ADDENDUM 2

PROJECT: Eugene School District 4J
Chinese Immersion Program Site & Building Renovation
at Kennedy Middle School (202014)
Eugene, Oregon

DATE: February 11, 2021

RE: Changes, Revisions, Clarifications and Additions

CIVIL DETAILS

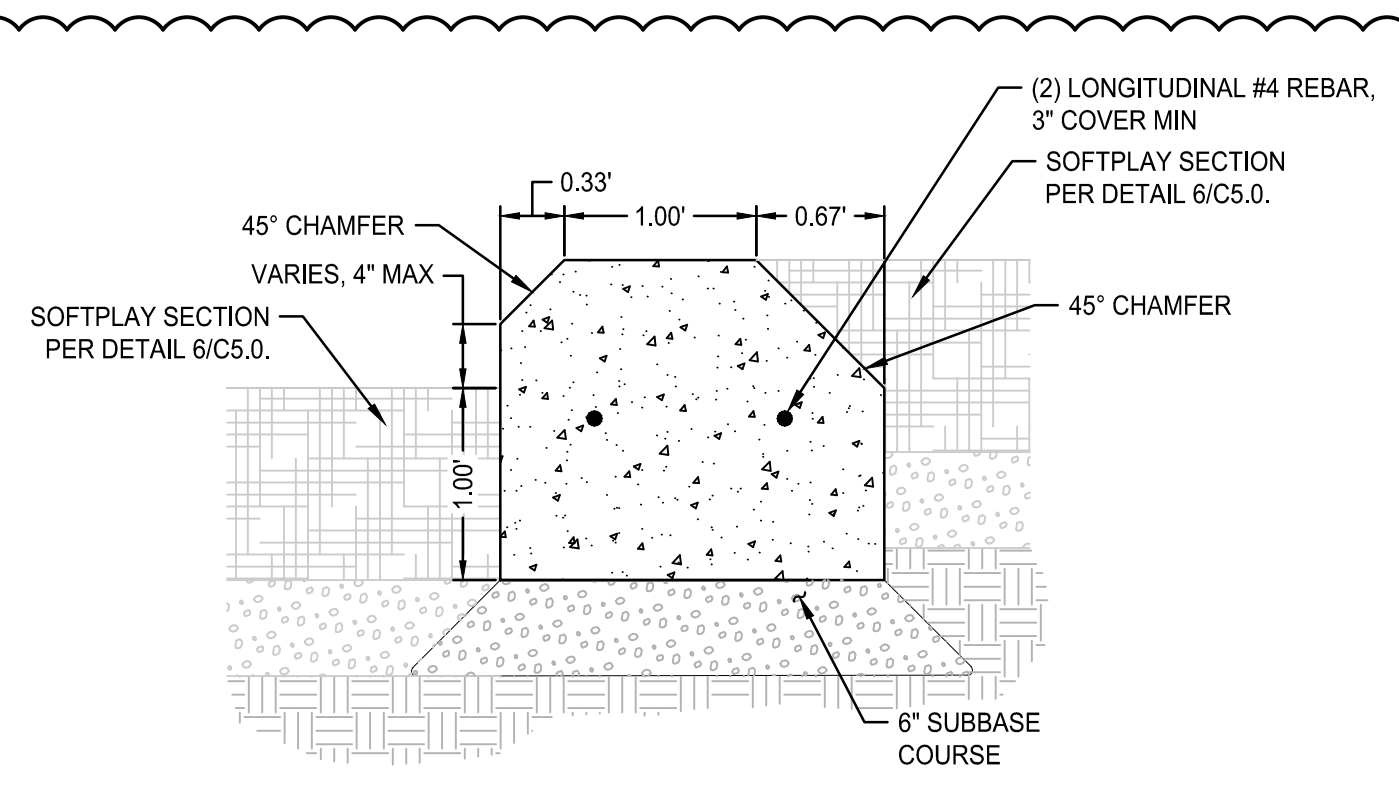
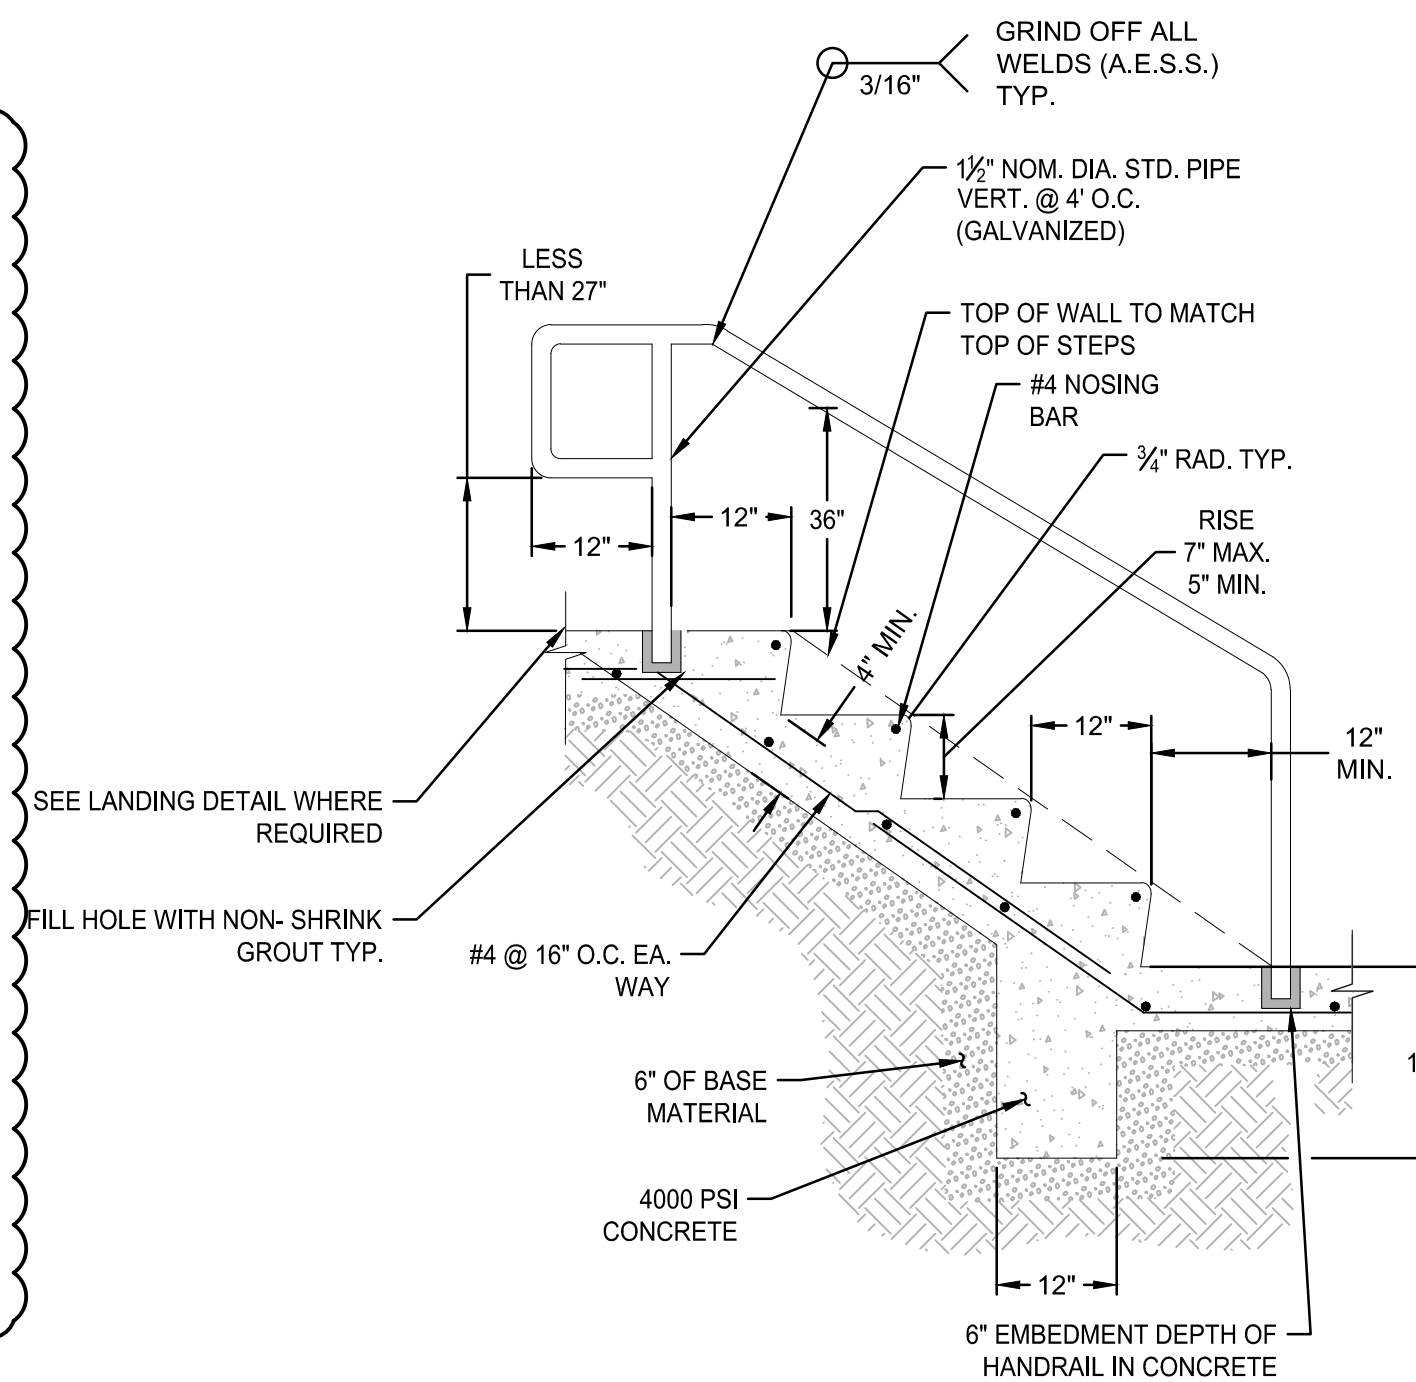
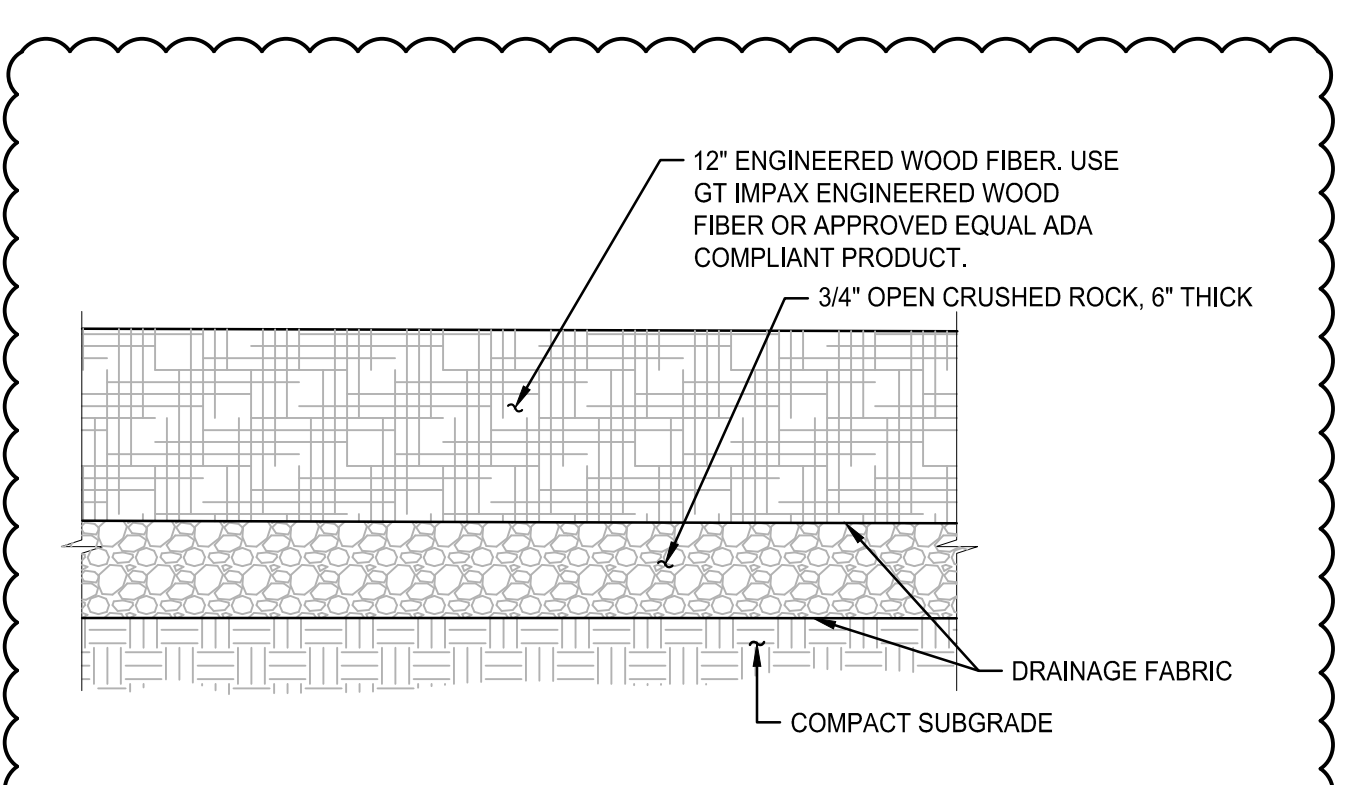
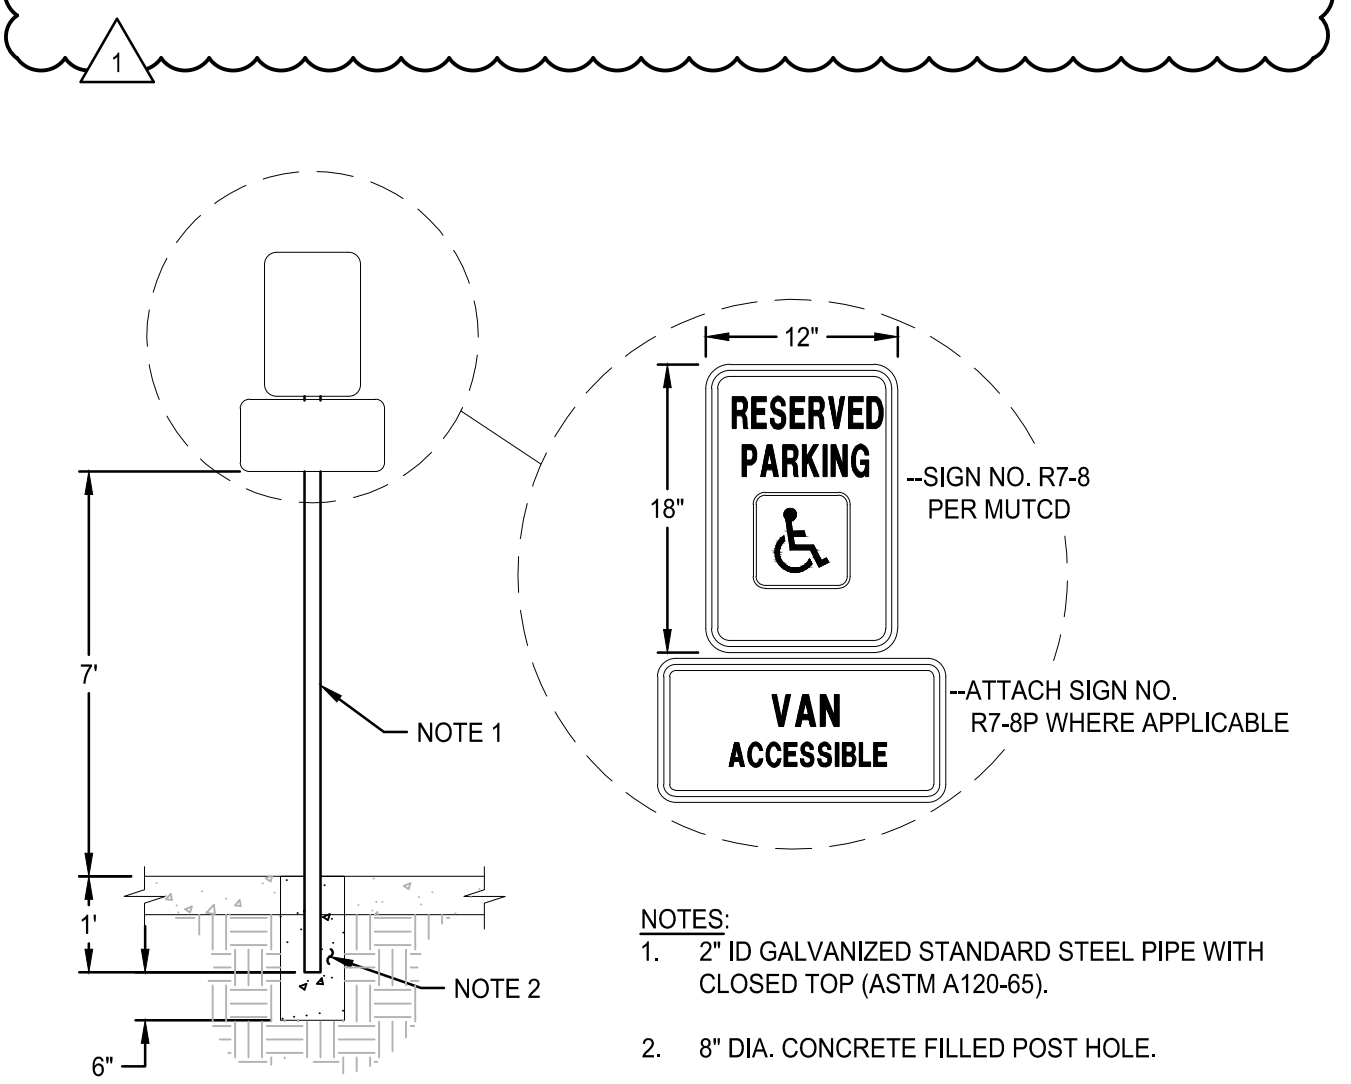
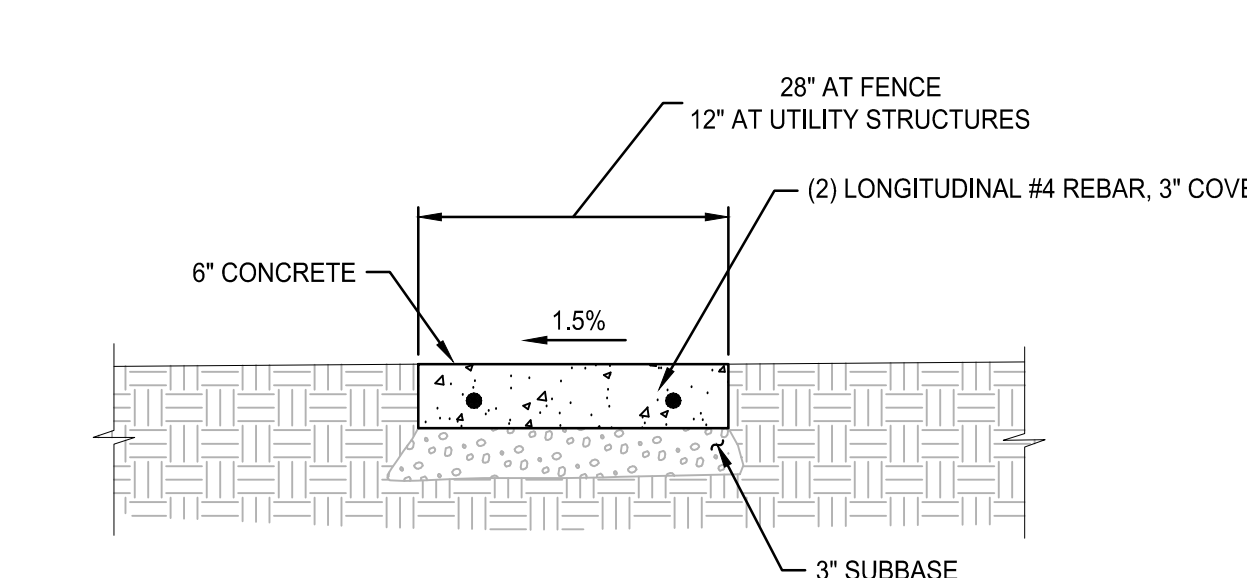
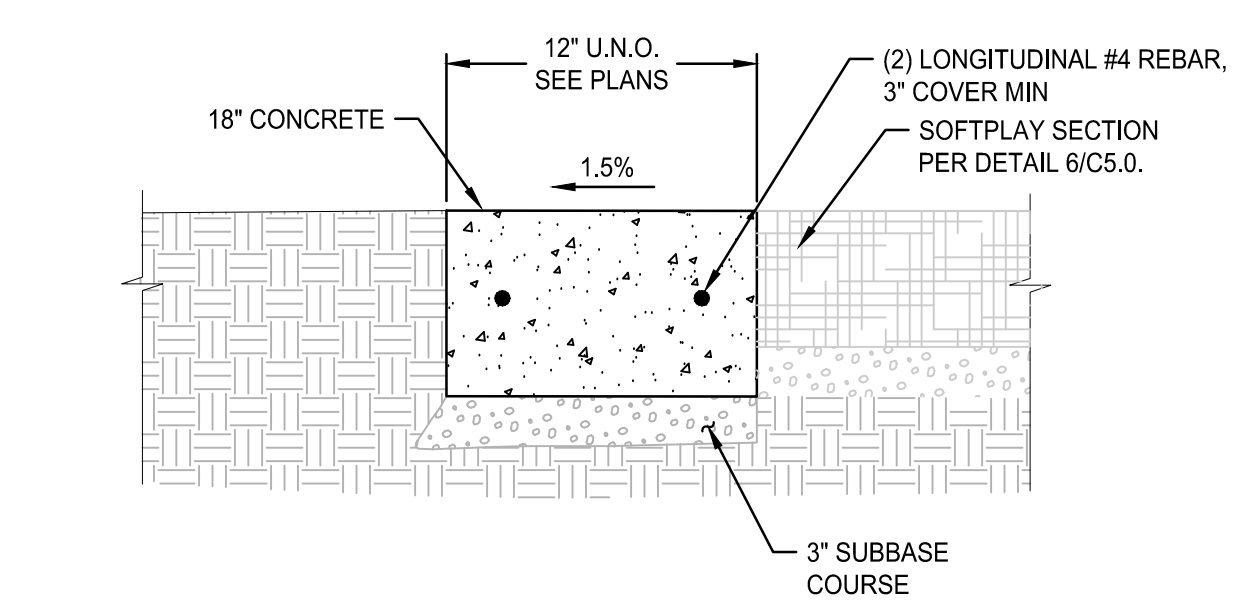
- Item 16: Reference Sheet C5.0 – CIVIL DETAILS dated January 27, 2021: Delete and replace with attached Sheet C5.0 – CIVIL DETAILS with revisions dated February 10, 2021.
